WILLYS-OVERLAND MOTORS, INC.
TOLEDO, OHIO

GENERAL LETTER NO. 752

SUBJECT: CJ-2A Lubrication Specifications

SUBJECT Model CJ-2A Manual Change

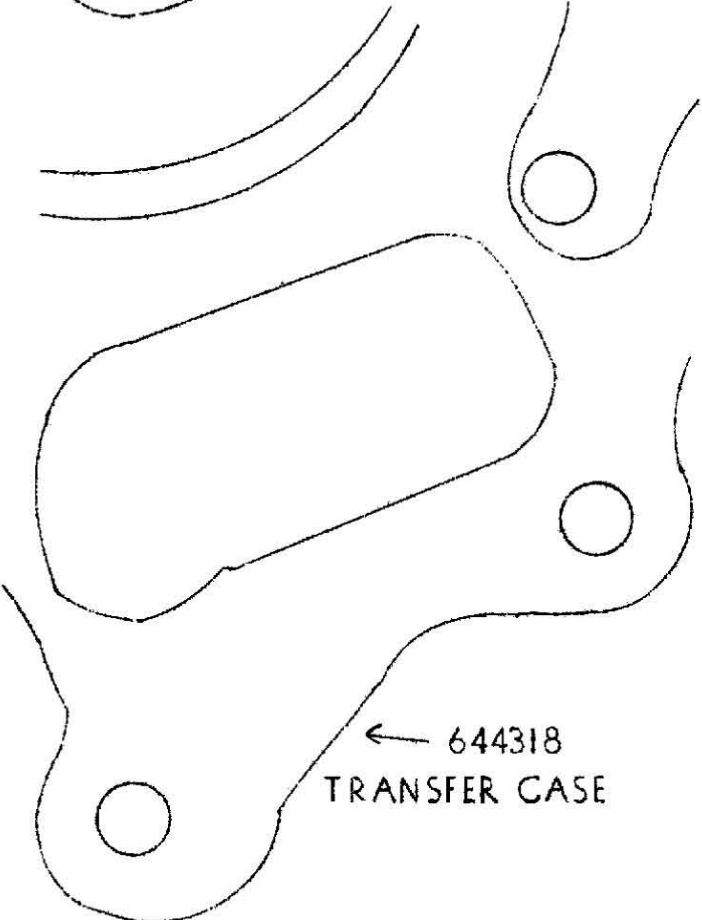
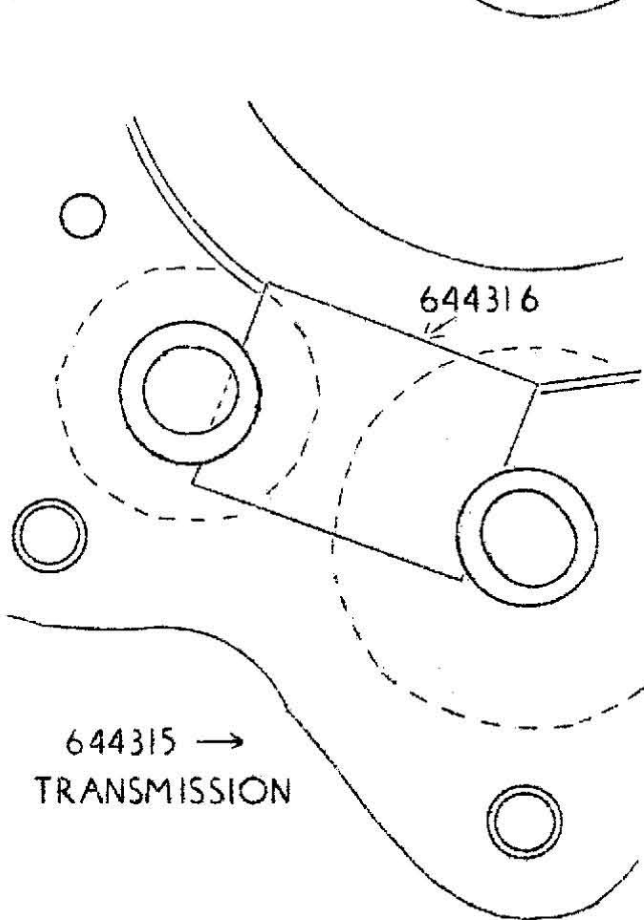
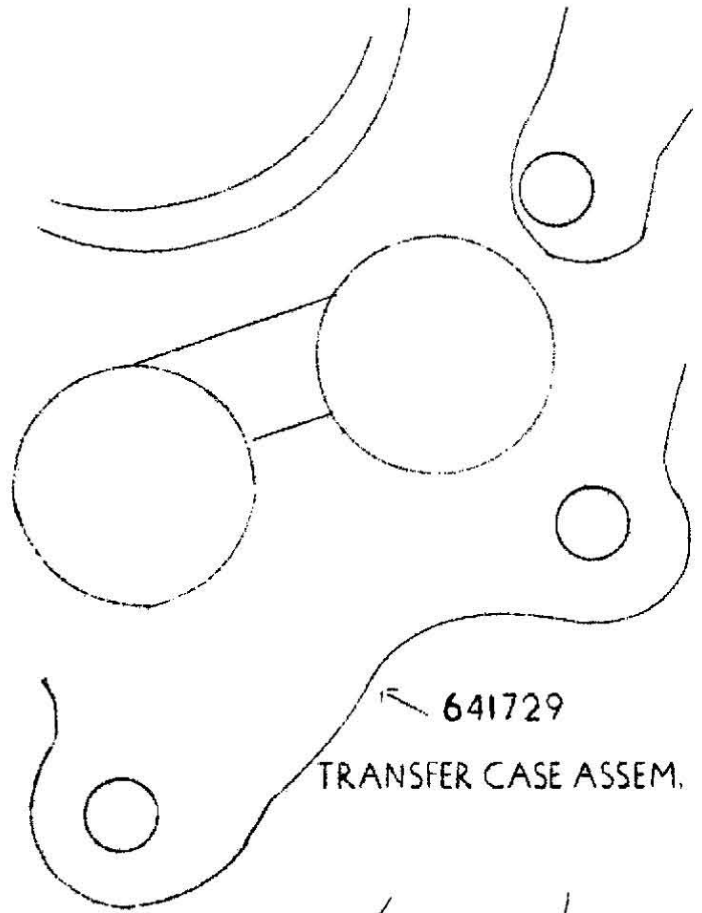
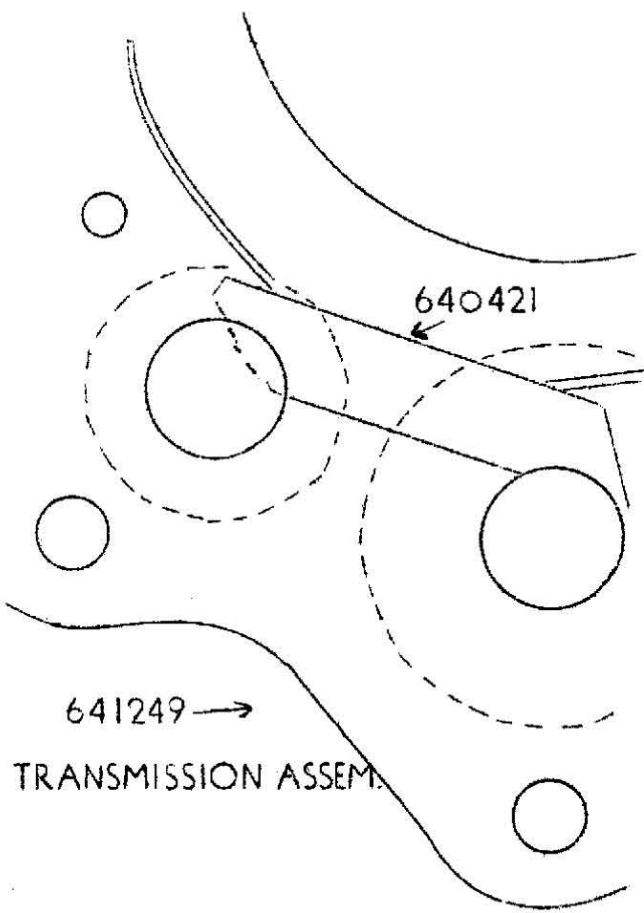
This change effects the part number of the transmission and transfer case assemblies only. The component parts are the same in both units except for the transfer case only, which is covered by new Part No. 644319 due to the cast recess.

Lock Plate Part No. 640421 can be used with either Transfer Case Part No. 641729 or 644318. Lock Plate Part No. 644316 can only be used with Transfer Case No. 644318.

When using Lock Plate No. 644316 in place of Lock Plate No. 640421, it will be necessary to drive the reverse idler gear shaft and the countershaft out about 1" and rotate the shafts to bring the lock plate slots in their proper relation to each other.

This change in lock plates requires a new transmission to transfer case gasket. New gasket Part No. 644122 can be used for service on all CJ-2A vehicles and supersedes Gasket Part No. 641731. Gasket No. 641731 cannot be used in any vehicle having the new lock plate. You should, therefore, order No. 644122 for all service requirements.

SUBJECT Carburetor Change-Nov
Governor CJ-2A

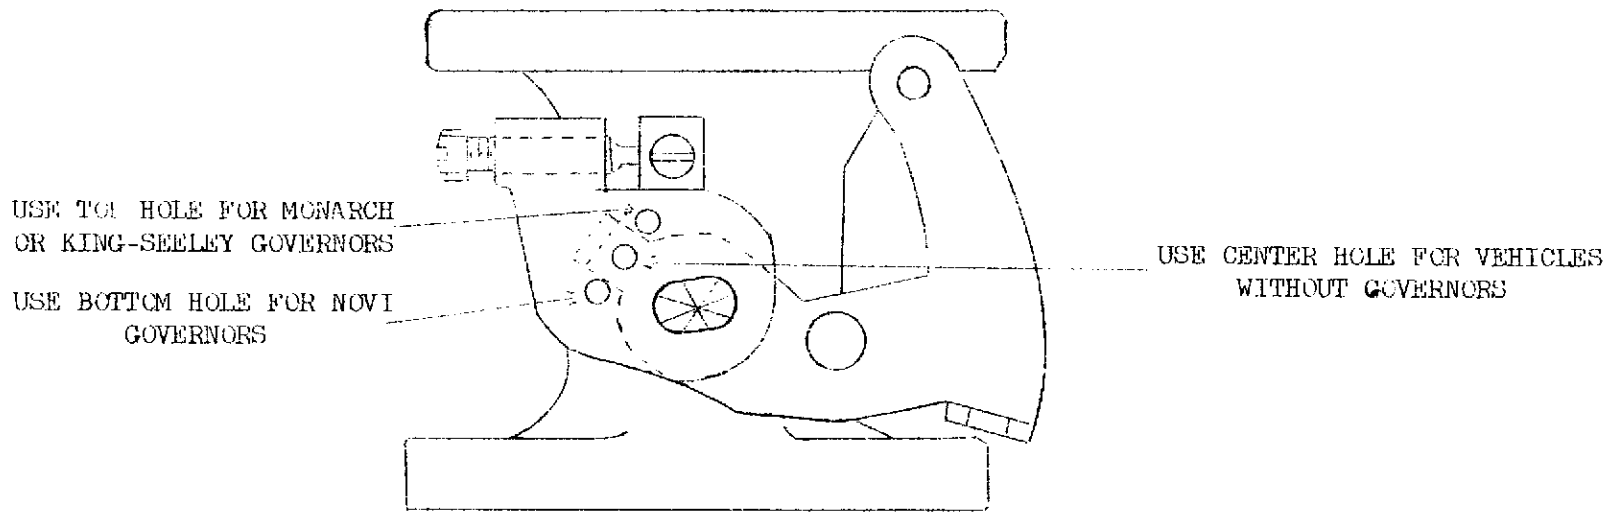
A new governor, just released for production, is now being installed on the CJ-2A "Jeep" and this governor also required change in the carburetor throttle control your Service Men must be familiar with.

On the present carburetors you will find three holes in the bell crank (engine side of throttle shaft). When no governor is installed on the vehicle the screw goes into the center hole and through the throttle lever locking the two parts as a unit. When the Novi Governor is used the screw is placed in the lower hole in the bell crank and below the throttle control lever. When the King-Seeley or Monarch governors are used the screw is placed in the top hole of the bell crank and above the throttle lever. IMPORTANT - Only when no governor is used are the bell crank and lever positively locked together with the screw. (See attached sketch).

The carburetor throttle is connected to the governor operating arm with an adjustable rod which is not spring loaded when the Novi governor is used and which cannot be used with the other type governors. The length of this connecting rod must be adjusted to assemble between the governor and the throttle arms when the hand governor control handle is pulled out to the 9th notch and the carburetor throttle is fully open. The adjusted length is approximately 6-3/4" between centers of the ball studs.

To check the governor adjustment, first start the engine and allow it to run until operating temperature is reached. Set the throttle idle stop screw to provide an idle engine speed of 600 to 650 rpm.

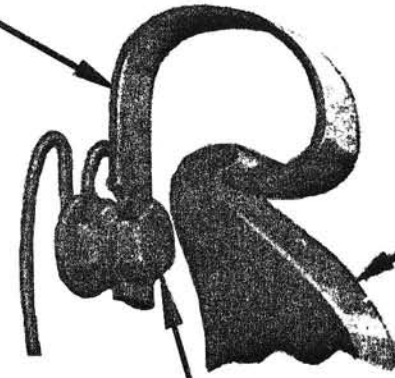
A new flat return clip spring, Part No. 649337, formed to proper shape, has been developed which will not only insure a clean disengagement, but will also prevent the rattling or "seltzer" noise mentioned above in the older type Auburn Clutch which is not equipped with the rubber inserts.

Attached hereto is a sketch showing how to install the new return clip spring which can easily be inserted through the inspection hole in the bell housing without dismantling the clutch or any other part of the vehicle.

It is recommended, however, that a light thread or string be attached to the return clip springs when making installation to prevent them from dropping down into the bell housing, which will cause a waste of time in fishing them out.

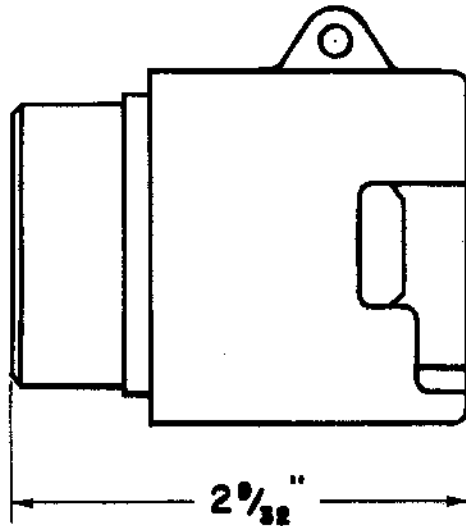
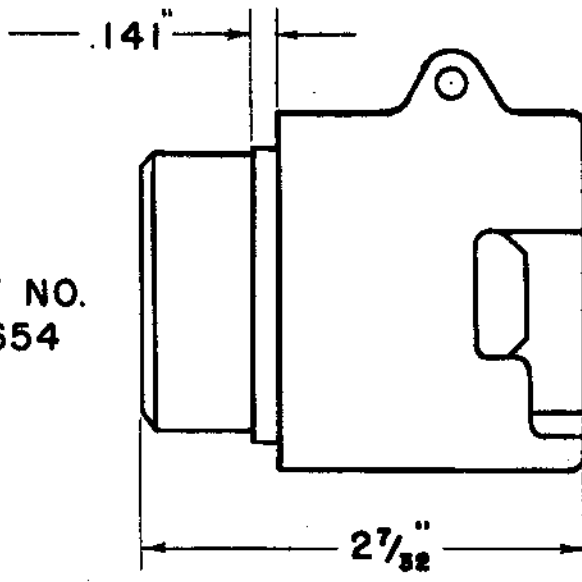
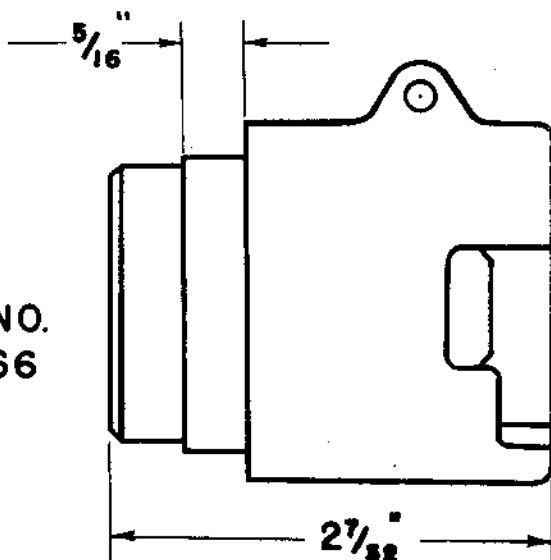
Part No. 637919	Models 4-41 and 4-42 Passenger Cars
Part No. 639654)	(Models CJ-2A and 4-63. These parts
Part No. 644366)	(are interchangeable for the above two
	(models, however, when buying new stock
	(order Part No. 644366.
Part No. 644366	Models 6-63, 2-WD and 4-WD

Use on Models 4-41 and
4-42 passenger cars only.

Use optionally on Models CJ-2A
and 4-63 with Part No. 644366.
When buying new parts order
Part No. 644366.

Use on Models CJ-2A, CJ-3A,
4-63, 6-63, 2-WD and 4-WD.

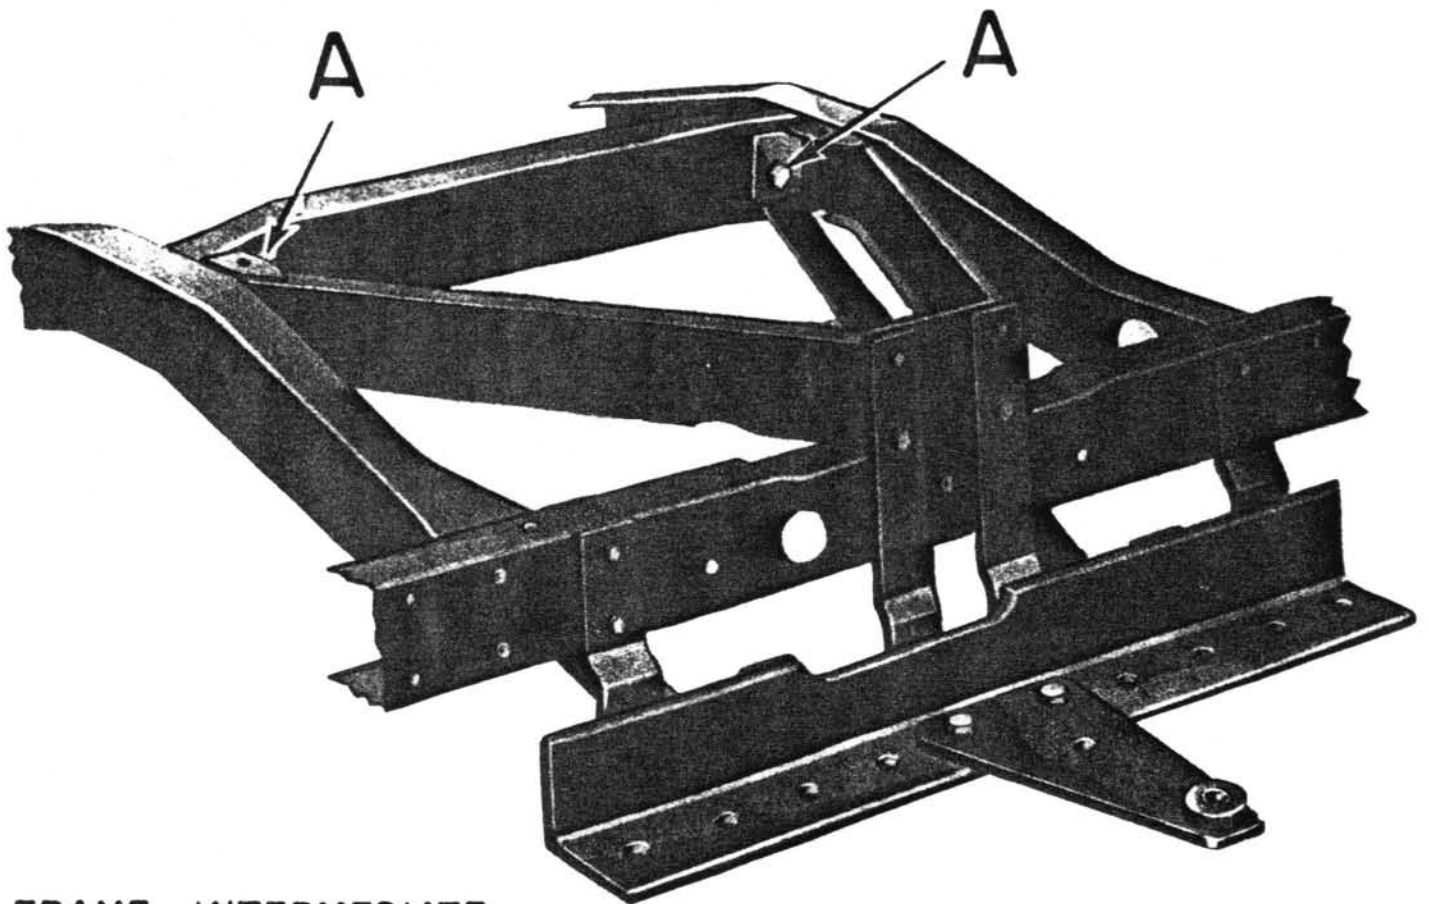
To make this change, first disconnect the draw bar support straps from the frame intermediate cross member. Enlarge the holes in cross member, the support straps and the two reinforcing plates from 13/32" to 19/32". Install the new 9/16" bolts with the old reinforcing plate next to bolt head and one of the new plates next to the nut. Install the new Hug Lock nut firmly without a lockwasher. The manner of making the installation is clearly shown in the attached sketch.

To avoid owner dissatisfaction, you should install these parts on all new vehicles before delivery. Arrangements should also be made to make the installation on cars in owners' hands, should you feel there is any possibility that draw bars will be pulled loose due to the manner in which they are being used. A labor credit of one hour will be allowed for this change, plus the parts, on all vehicles that are within the guarantee period.
